**RE: Revised Grading Plan (C-18D012)
American Toyota
Albuquerque, New Mexico**

The purpose of this letter is to accompany the enclosed revised grading plan. The plan has been revised to accommodate your written comments dated 12/23/14. The following is a summary of your comment and the narrative as to how we addressed

REVISED
DRAINAGE REPORT

AMERICAN TOYOTA EXPANSION
Albuquerque, New Mexico

PROPOSED HYDROLOGY

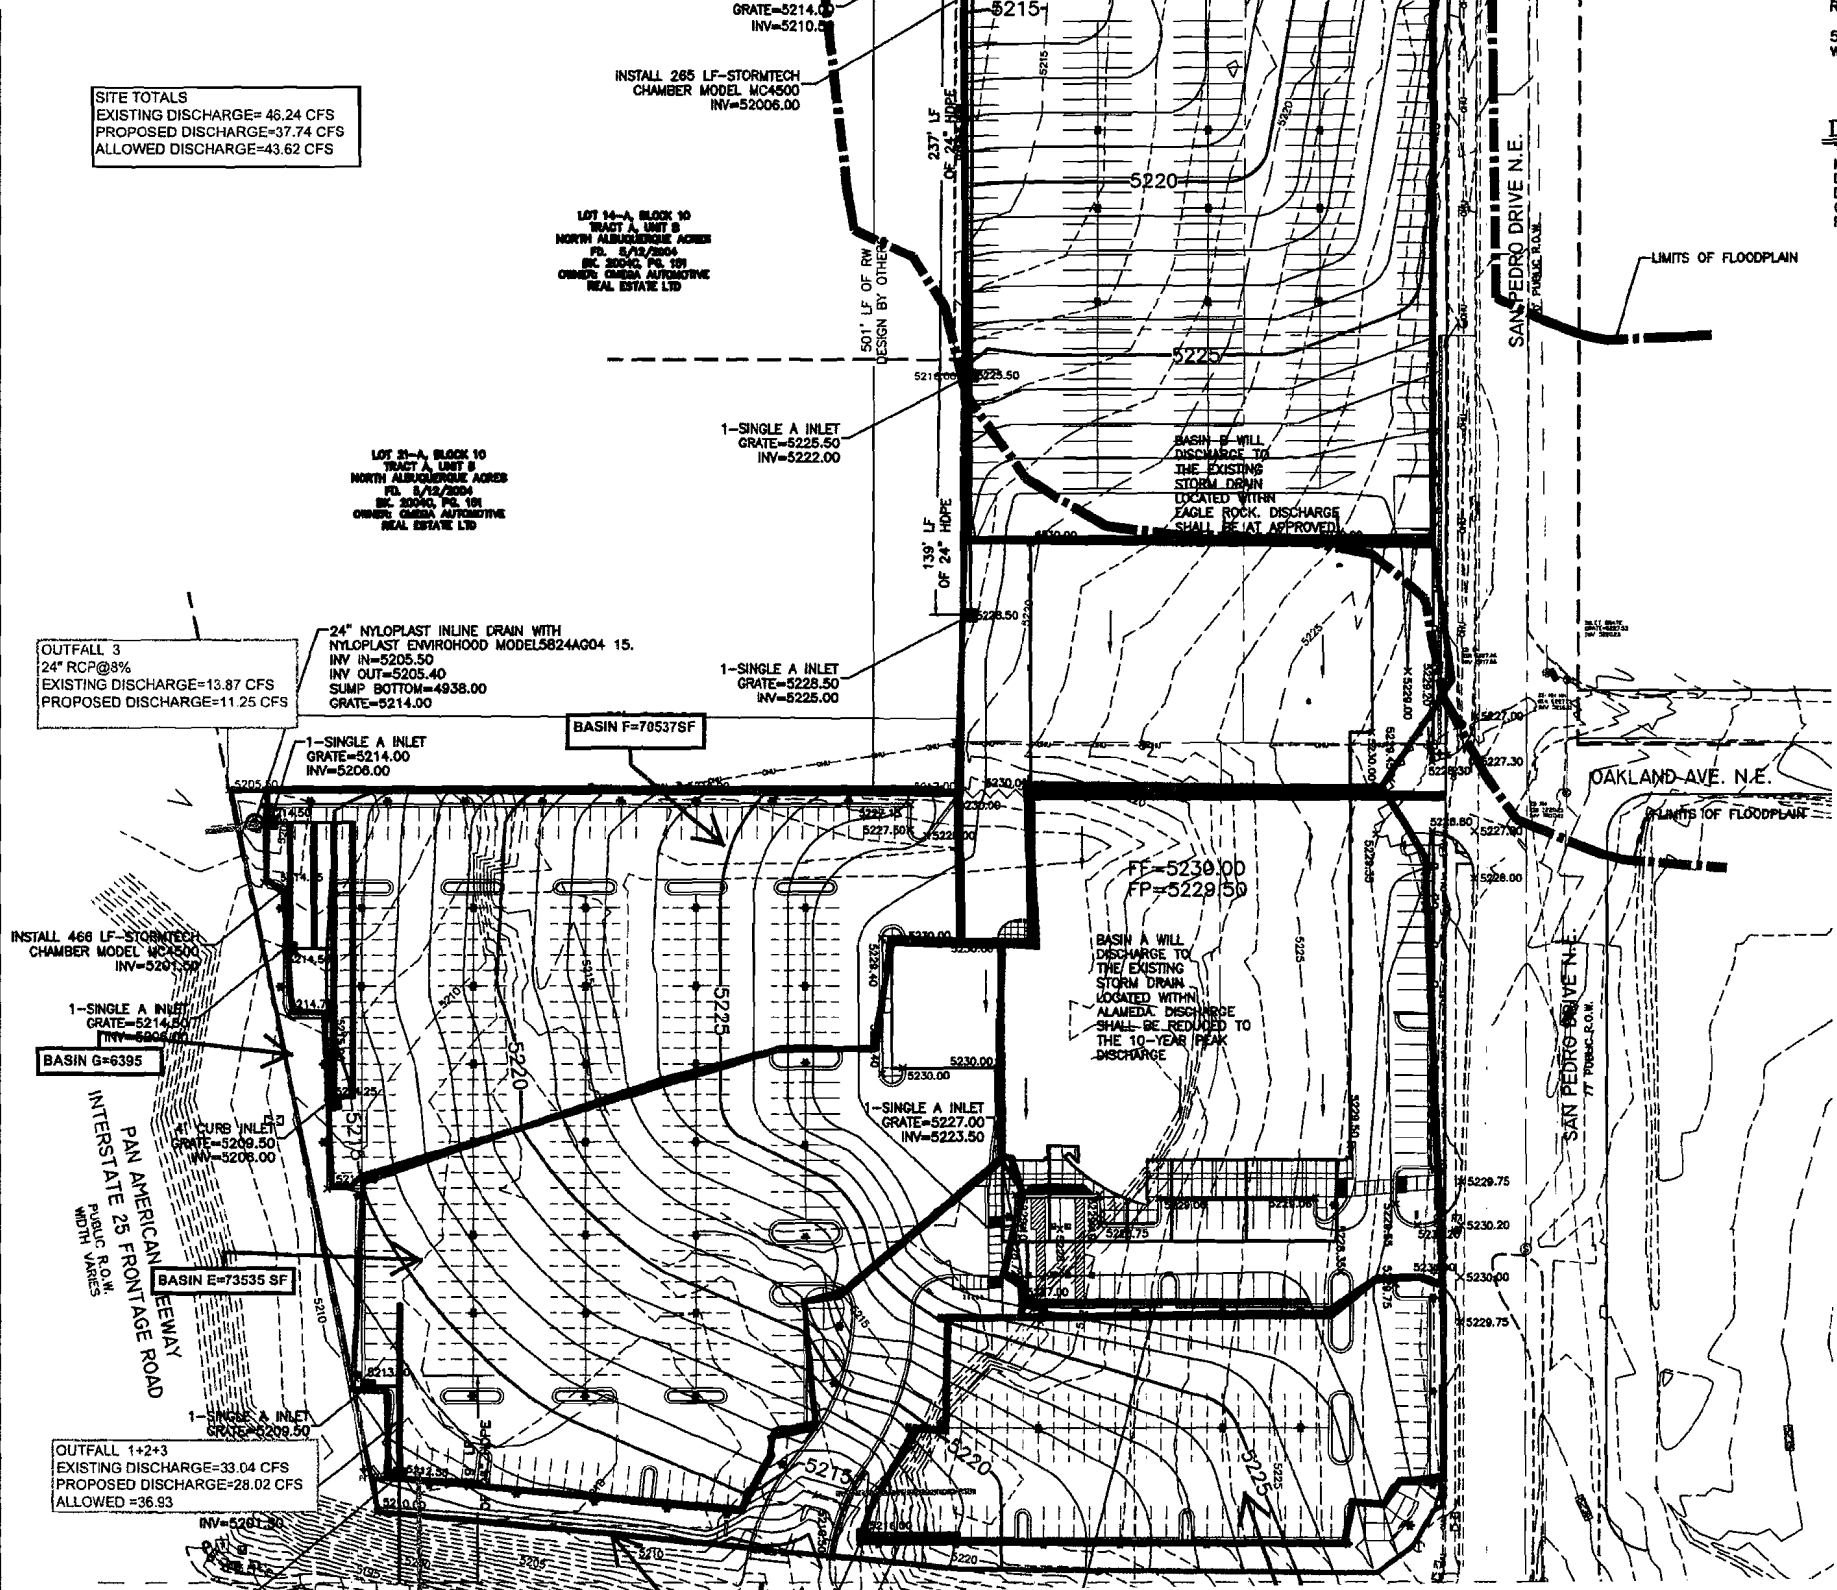
5. On the proposed basin map, show the allowable and proposed area, flow and volume for each basin. For each Stormtech system, show the flow and volume in and out. show proposed flow and volume being discharged off site. Show allowable and volume at each location. label basins and roads.

We have added more detail onto the proposed basin map. In addition we have shown existing flow for each discharge point and a comparison of allowed flow to existing and proposed.

STORMTECH DETAILS AND CALCULATIONS

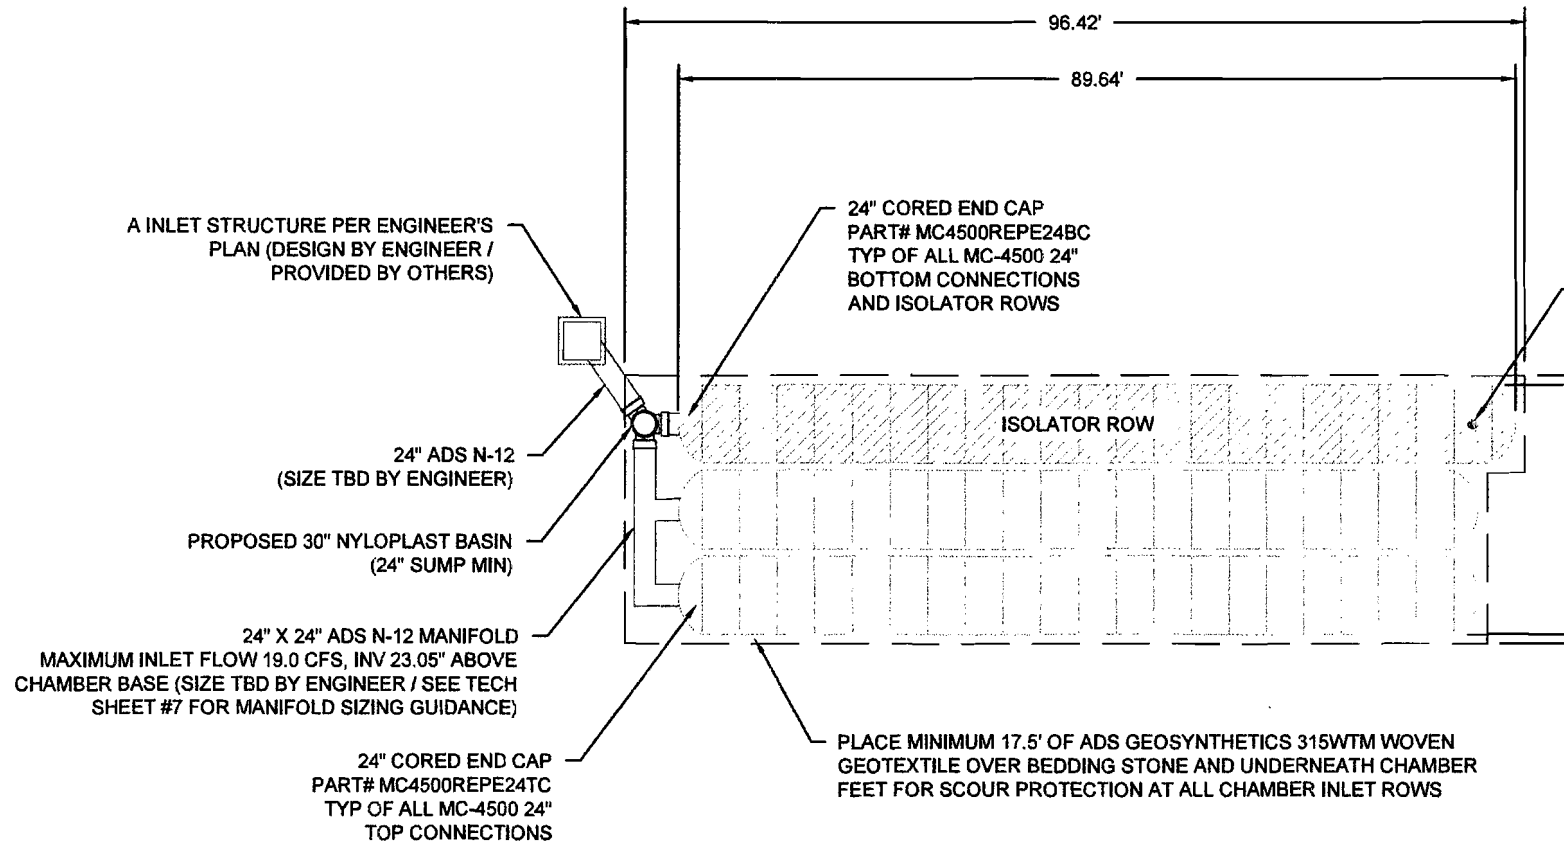
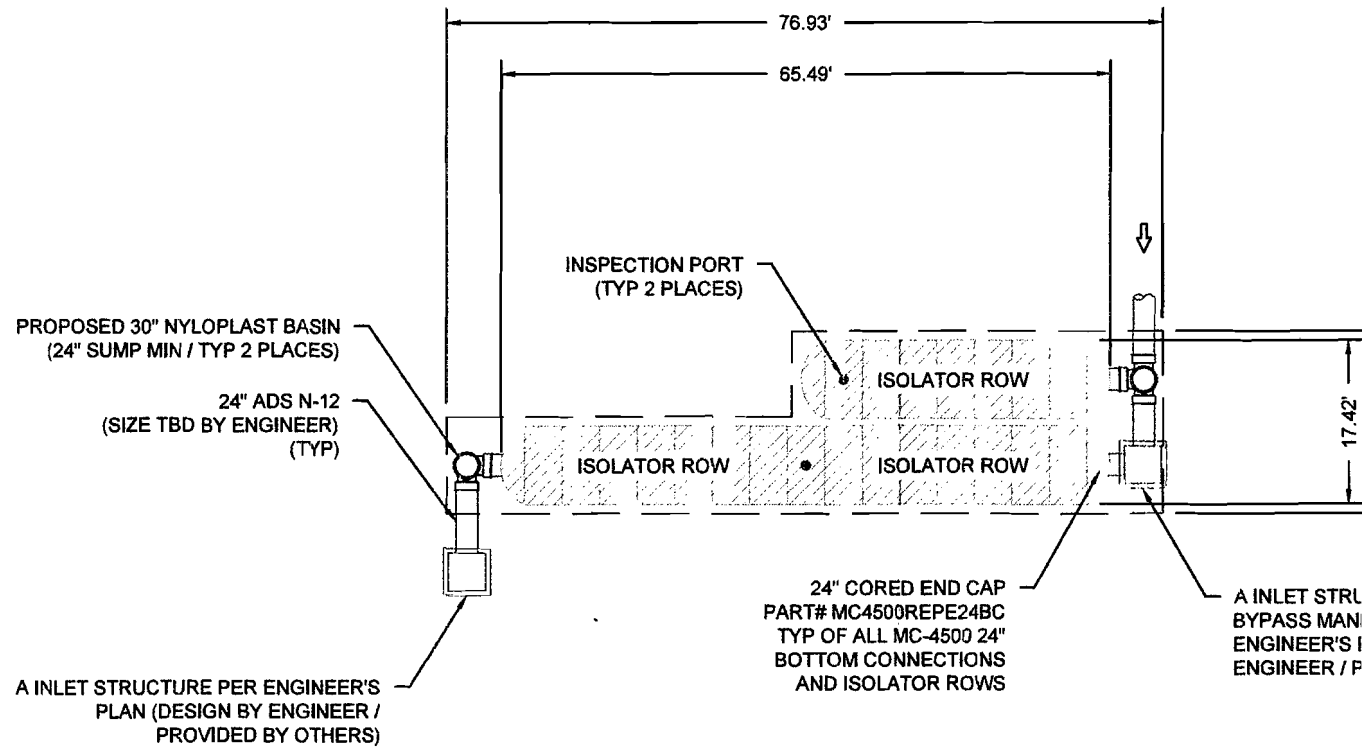
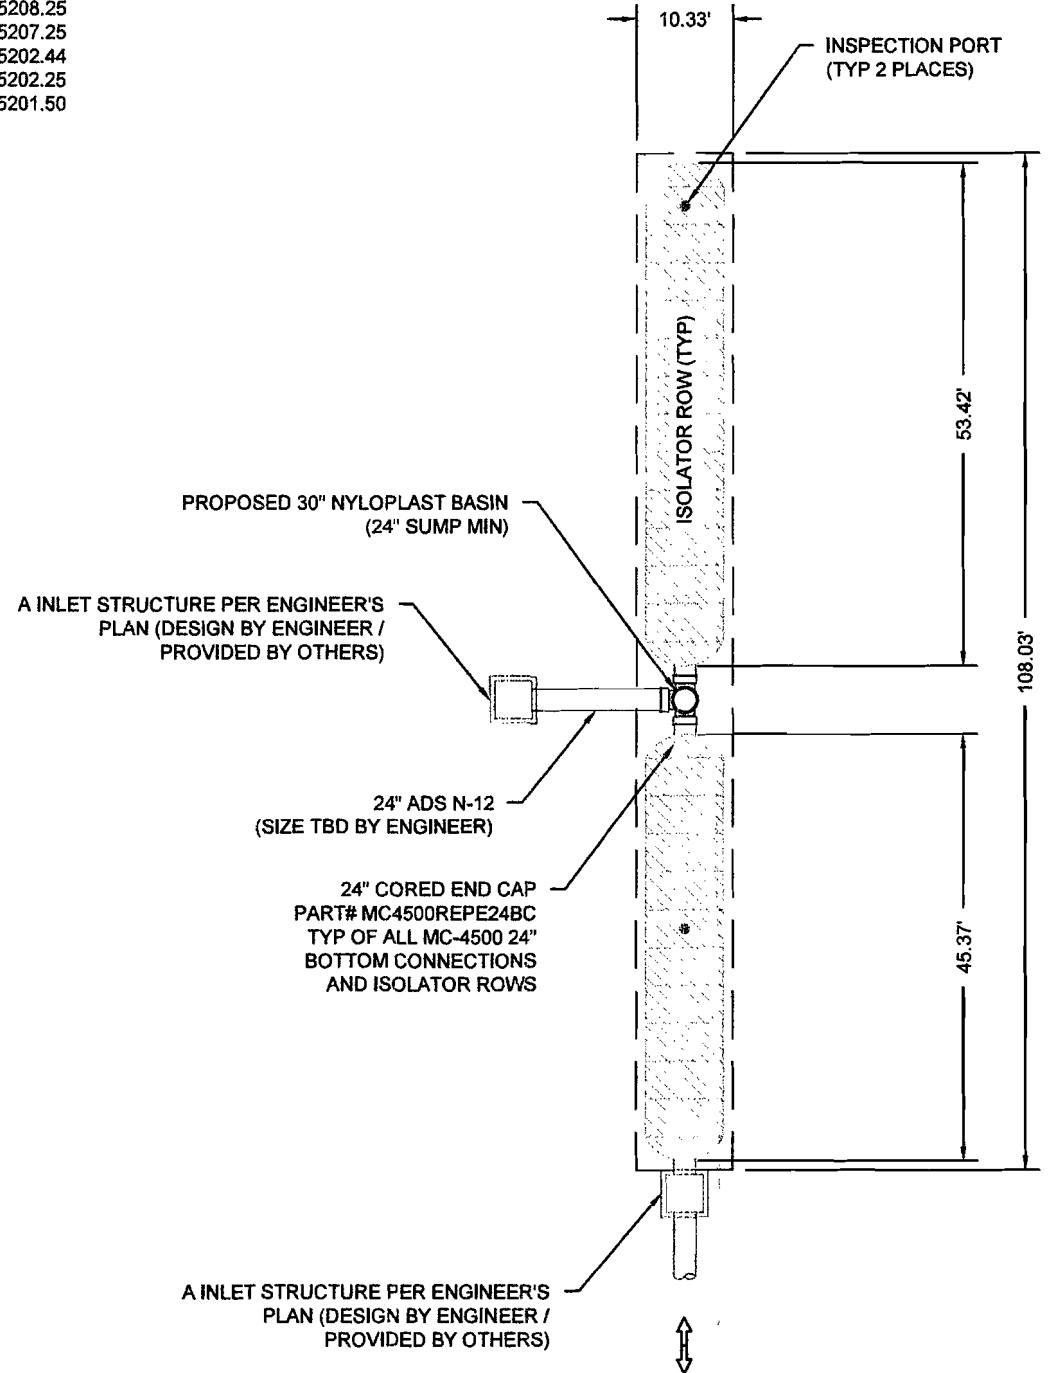
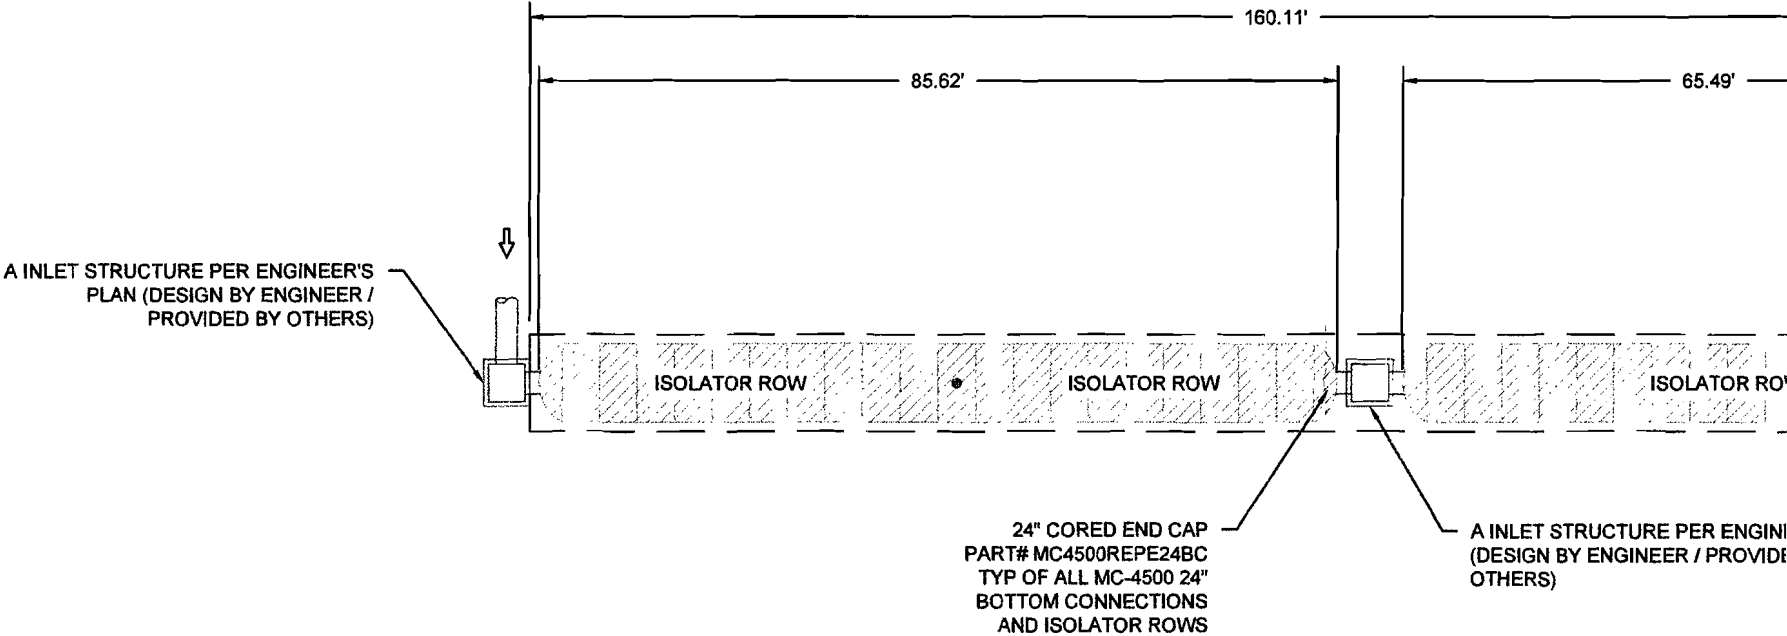
7. Include calculation for the design of the stormtech systems

8. Provide a detail sheet for storm tech system specific to this site

9. How will the storm tech manifold system be done. Provide detail of how to be built

We have included details and calculations for each system,

We have included the details from the manufacturer.

We have included details of system and layout.
